City of Long Beach

September 21, 2017

RE: Long Beach Groin Failures

Figure 1. Head of Groin 32 (courtesy of Shewen Bian)

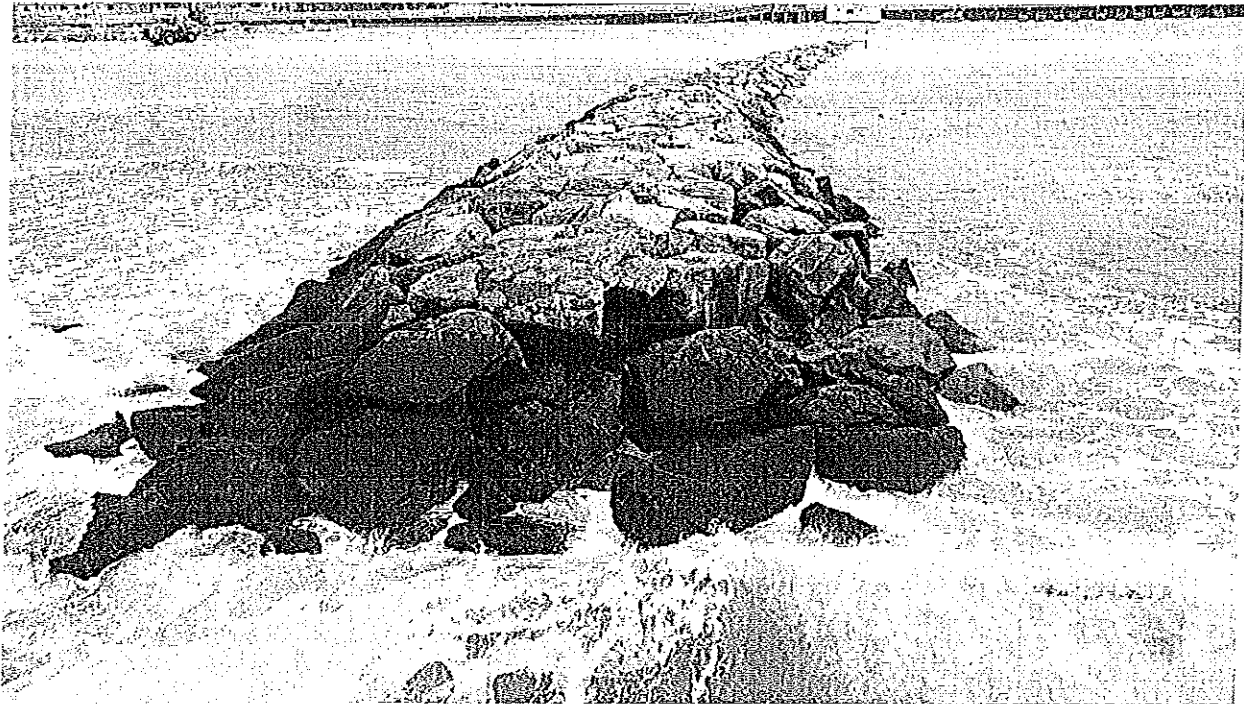
The photograph below of Groin 32 located on Grand Boulevard provides an example of the structural failure we have observed (Figure 1). From the photograph, it is apparent that armor

stone boulders on the seaward portion of the groin slope have slid seaward and down, resulting in separation along the top and east (right) side of the groin. Several factors can contribute to this type of failure, including the use of boulders of improper shape, size or weight, non-interlocking boulder placement, lack of adequate foundation for scour protection, and/or the lack of overall structural stability sufficient to combat wave activity.
